County of Santa Clara
Department of Planning and Development

DATE: December 16, 2020
TO: Airport Land Use Commission
FROM: Mark Connolly, Senior Planner / Deputy Zoning Administrator
SUBJECT: City of San Jose General Plan Amendment and Rezoning for the Downtown West project

Consider recommendations relating to a request from the City of San Jose for a General Plan Amendment and Rezoning for the Downtown West Project, within the Airport Influence Area of San Jose International Airport (SJC). (City of San Jose Planning File Nos. GP19-009, PDC19-039-multiple parcels)

Figure 8
Existing Ground Elevation

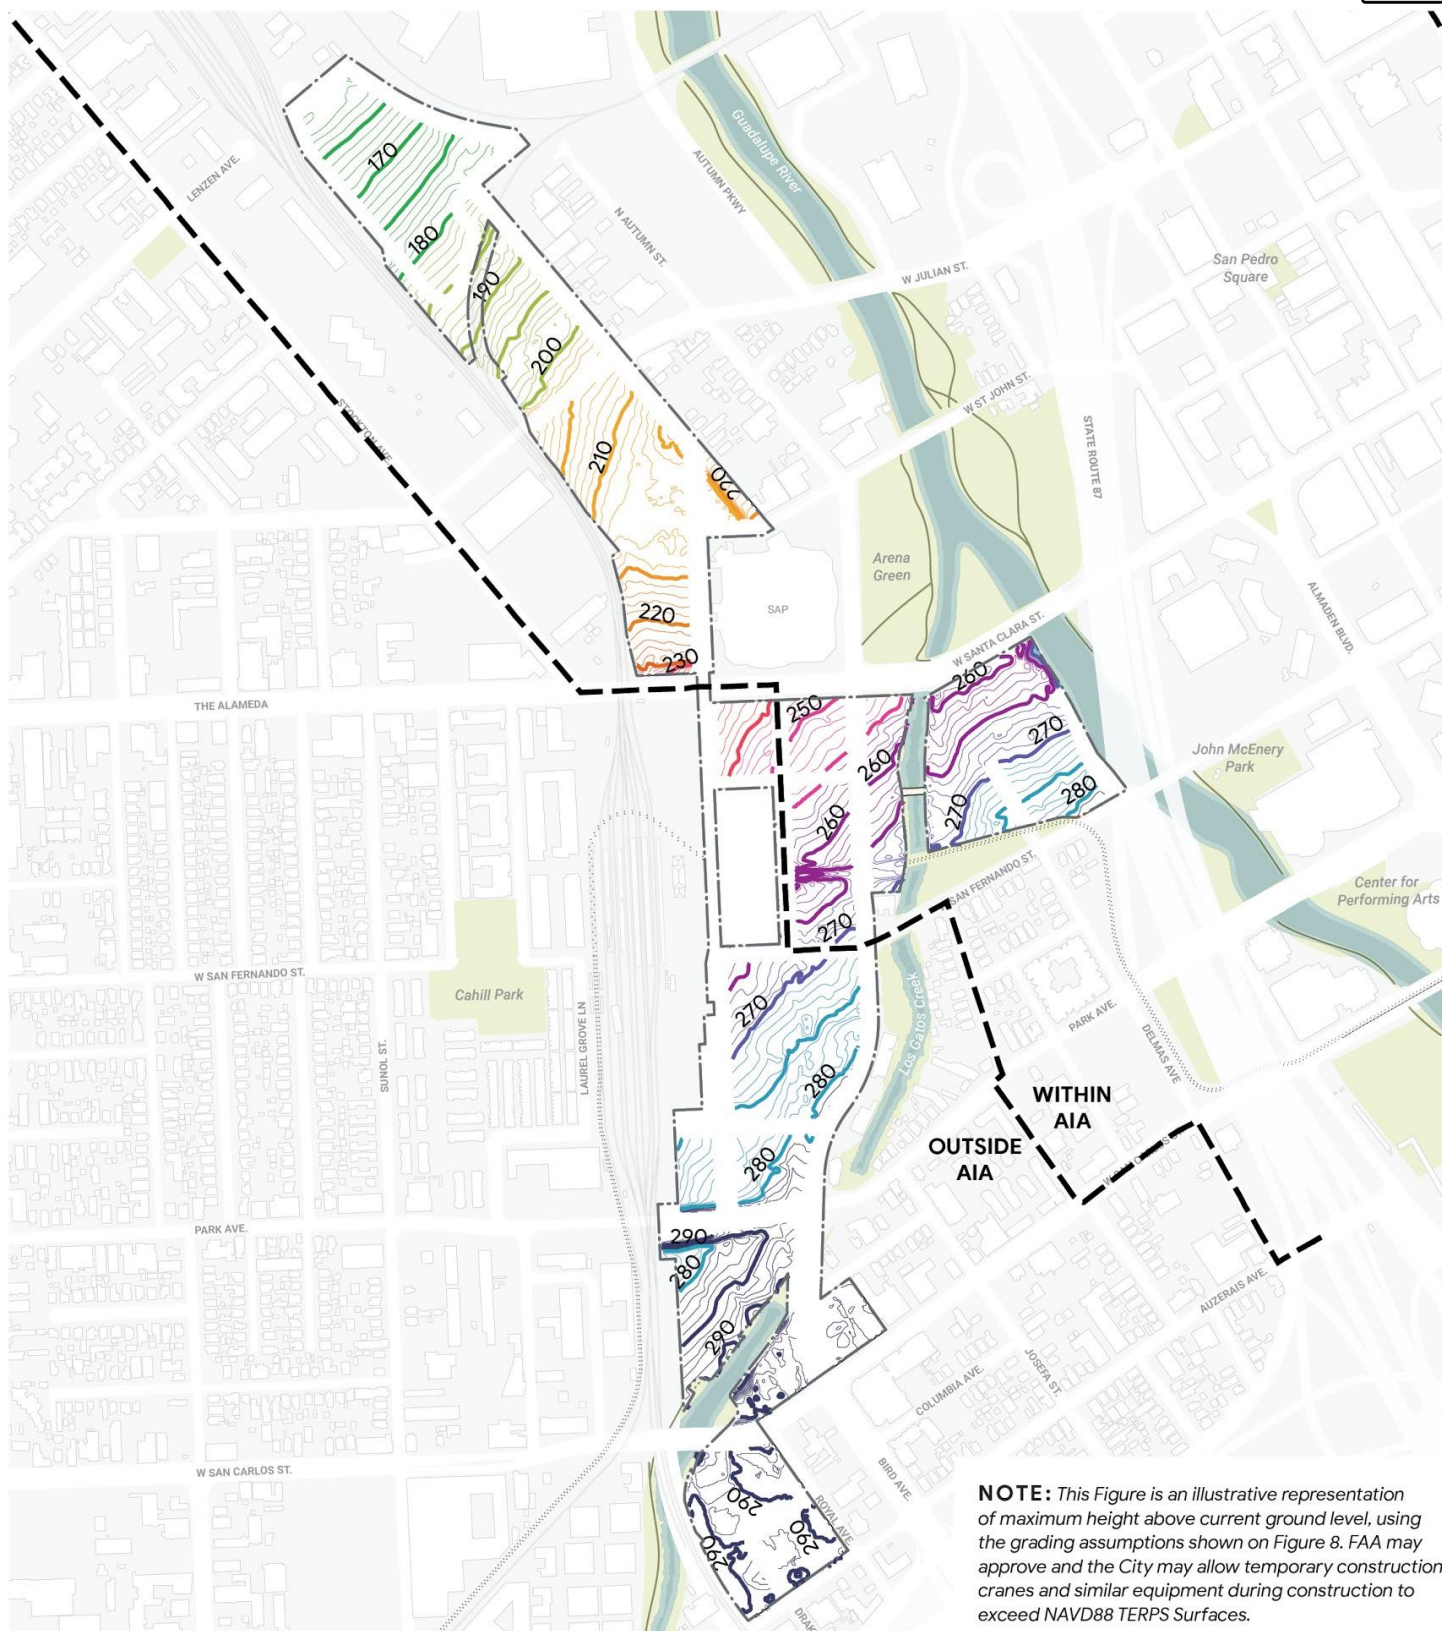
Figure 6 of the referral shows “existing heights / OEI”, but is actually the FAA FAR Part 77 surfaces. Figure 7 shows the Terminal Instrument Procedures (TERPS) surfaces. And Figure 7 shows the ground elevations. In June of 2020, the San Jose City Council adopted TERPS as the height limitation surfaces for the area south of SJC.

Fig. 8 Existing Ground Elevation is the approximate existing elevation of the Project site subject to change after completion of final grading. In all instances, heights will remain within the NAVD88 contours.
